# BALLINA FLOOD RELIEF SCHEME PUBLIC CONSULTATION EVENT NO. 2

MGW0290  
Ballina Flood Relief Scheme Public  
Consultation Event No. 2  
S6.P01  
10 July 2023

**REPORT**

# Knockanelo Proposed Flood Defence

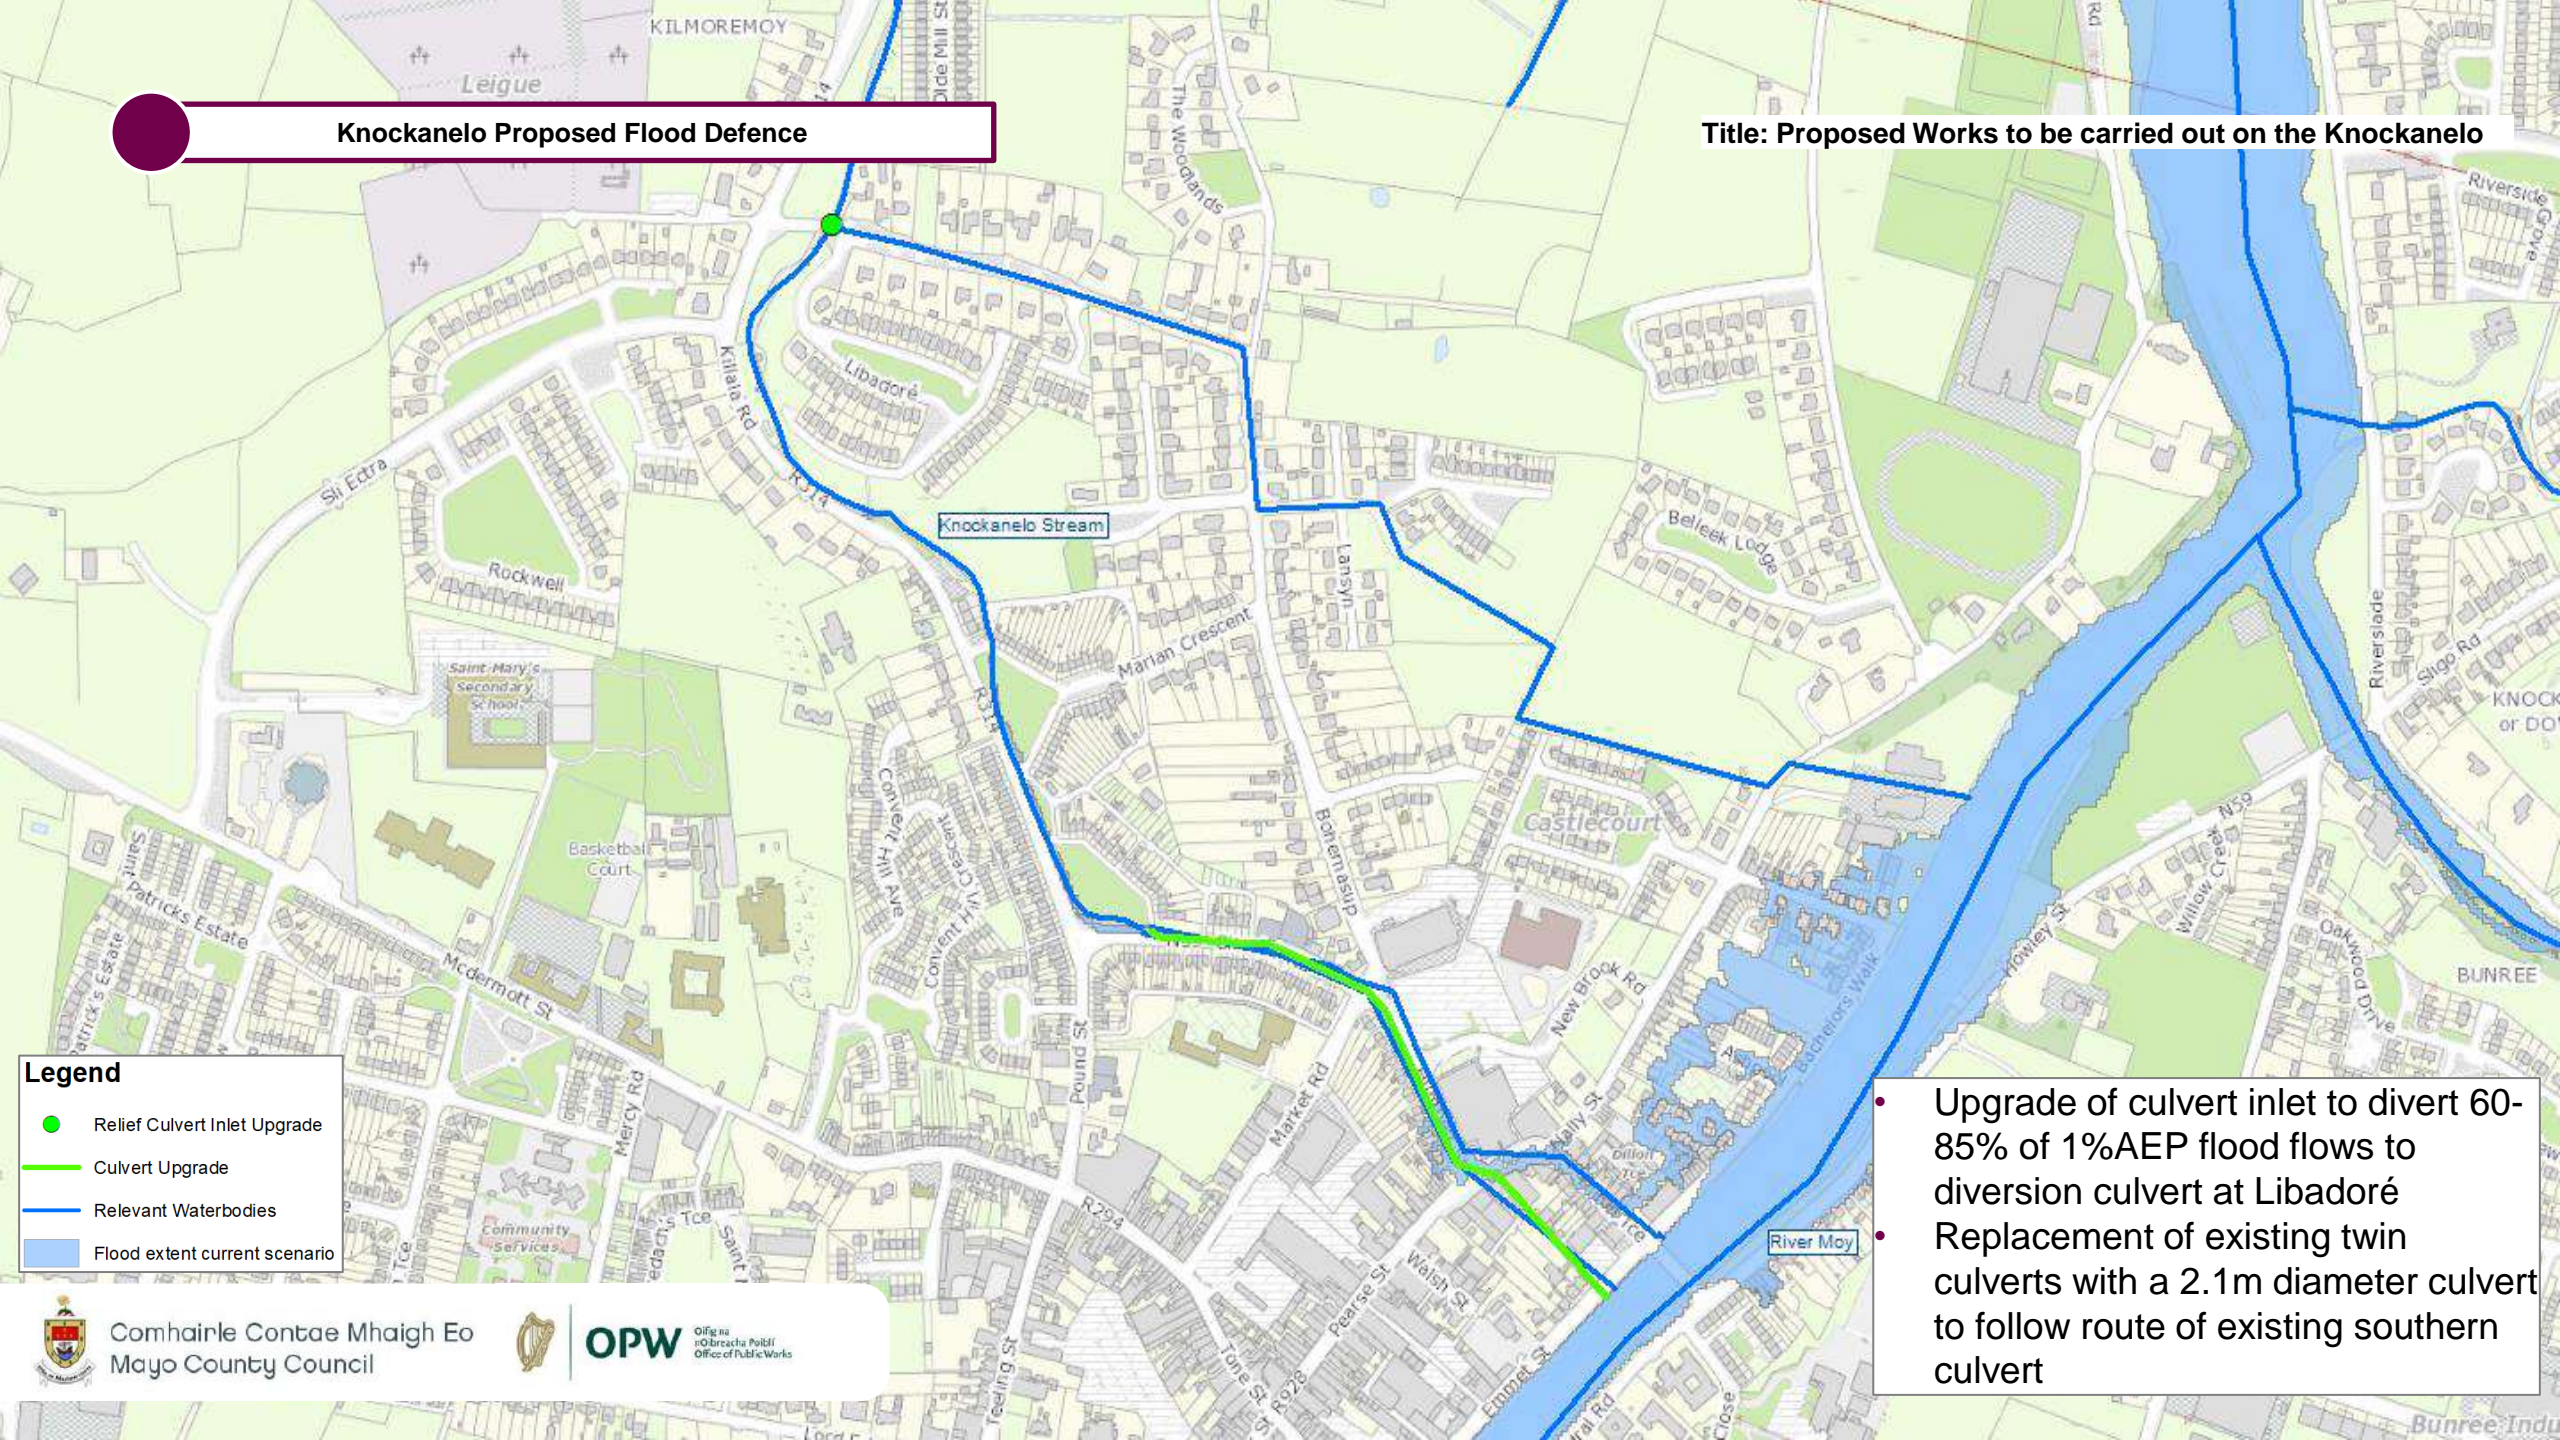
7. The Knockanelo Stream historically provided habitat for sea trout and brown trout, unfortunately due to the installation of poorly designed culverts this watercourse is now impassable to migratory fish. The upper catchment has also been negatively impacted by land drainage. This catchment has been allocated moderate ecological status in the River Basin Management Plan and this status must be improved to good to comply with the Water Framework Directive. The Knockanelo Stream has been identified as being at risk of not achieving this target due to significant hydromorphology pressures including the barrier to fish movement caused by the existing culvert design and trash grates. The proposed culvert upgrade provides an opportunity to restore fish passage in this watercourse. The culvert could be improved in a number of ways, reduce the gradient from the upstream end to the downstream to less than 3% with internal baffles used where this slope is exceeded. The internal gradient must not exceed 5%. Light levels can be increased by increasing the height of the culvert and introducing light boxes or opening up sections of the culverted watercourse where possible. Section 6.10 and 6.11 of the 2016 Guidelines on Protection of Fisheries During Construction in and Adjacent to Waters. Provides information on culvert design. IFI must be consulted on the detailed design of the proposed replacement culvert.
